June 30, 1983  
G02-83-584

Subject: NUCLEAR PROJECT NO. 2  
SAFETY EVALUATION REPORT (NUREG-0892)  
CONFIRMATORY ISSUE NO. 7 - COMPONENT SUPPORTS

110.40 SER Confirmatory Issue No. 7 - Component Supports

SAFETY EVALUATION REPORT  
 WNP-2 CONFIRMATORY ISSUE NO. 7  
 - COMPONENT SUPPORTS -  
 PHASE I STUDY FLOW CHART

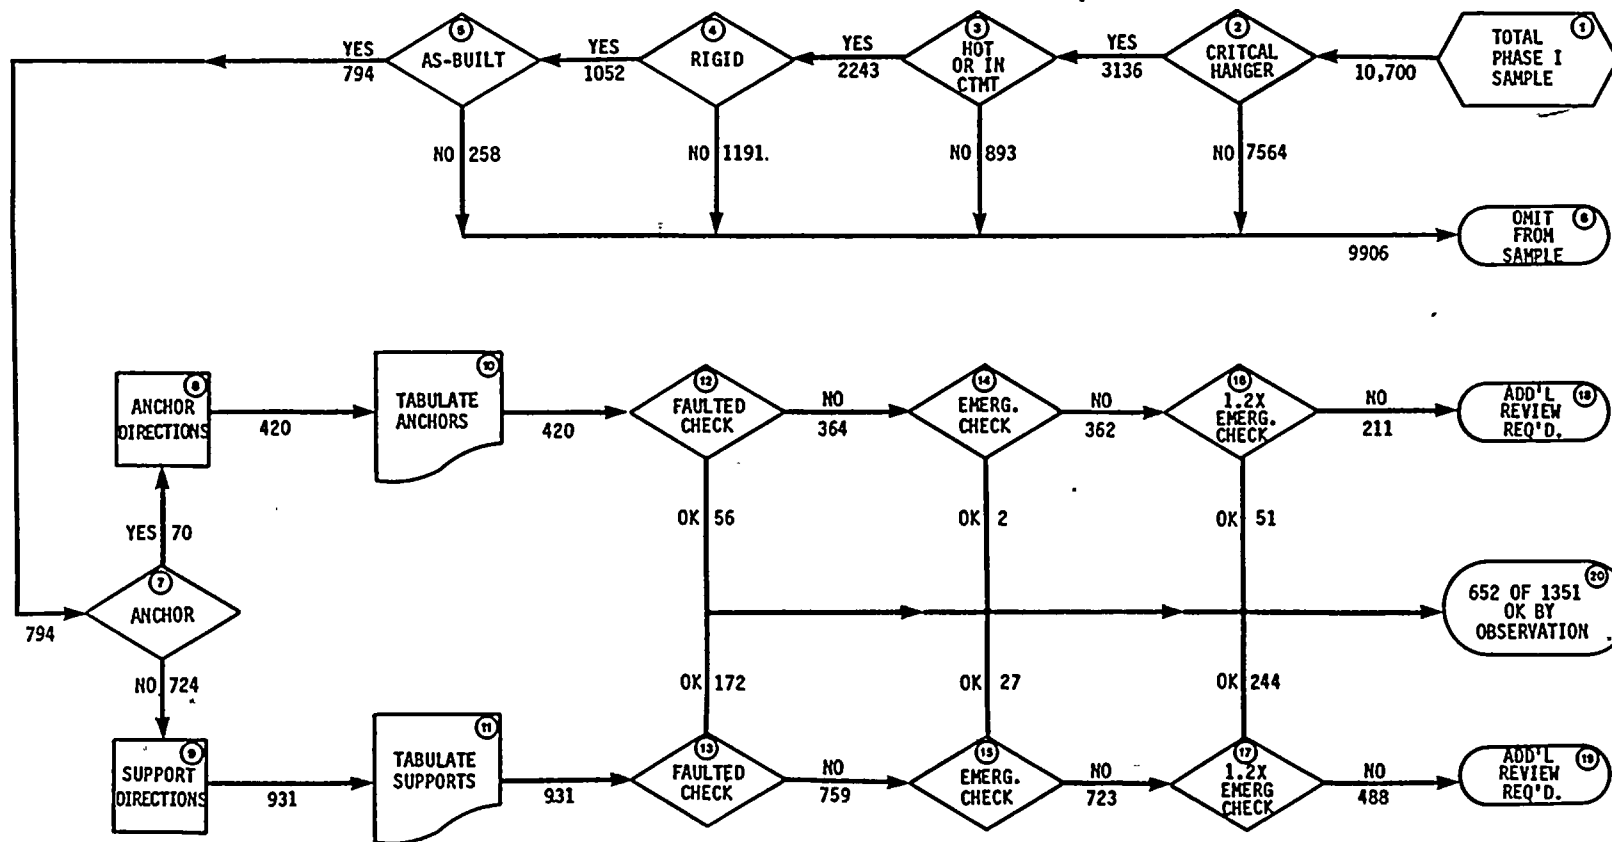
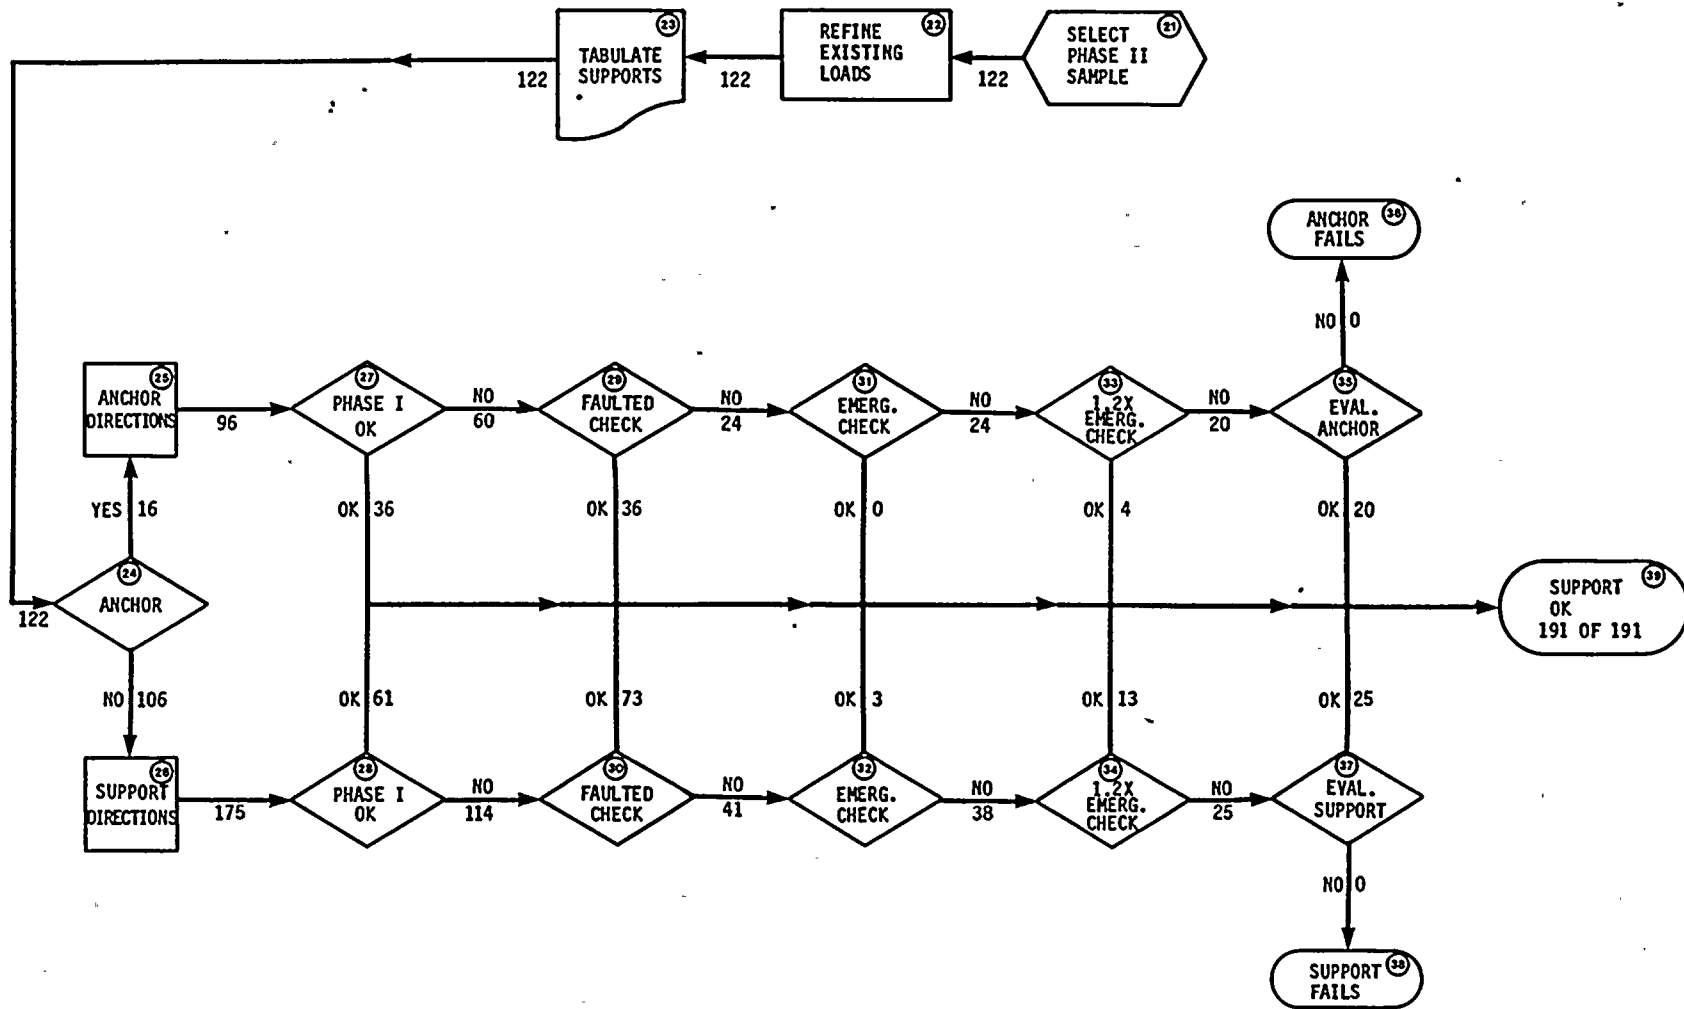
1. In addition to the information submitted in the above referenced letter, provide a response to the staff's position for all remaining component supports, such as those for pumps, heat exchangers, filters, etc.

- a. Of the 1500 rigid piping supports which are affected by the addition of thermal loads to the faulted condition loads, identify those that exceed the specified allowable stress limits and by what amount.
- b. For all supports identified in 2a above, justify the acceptability at the predicted stress. Such a justification could demonstrate that support failure does not occur even if the design limit is exceeded or could utilize inherent design conservatisms. If this justification includes the consideration of inherent design conservatisms, provide a quantitative discussion of how such conservatisms were applied to the analysis.

Each paragraph describes numbered steps identified on the attached flow charts. These steps define the process used in evaluating WNP-2 large bore piping supports as described in paragraph III.E.2 of letter G02-82-1021 dated December 30, 1982, G. D. Bouchey, Supply System, to A. Schwencer, NRC.

- 36) No anchors failed.
- 37) Twenty-five support directions required additional review to confirm design adequacy.
- 38) No supports failed.
- 39) In conclusion, 175 supports and 16 anchors were evaluated in Phase II and all were found acceptable. The predicted primary stress combination with all support loads resulting from normal piping thermal expansion classified as primary were less than the allowable stress.
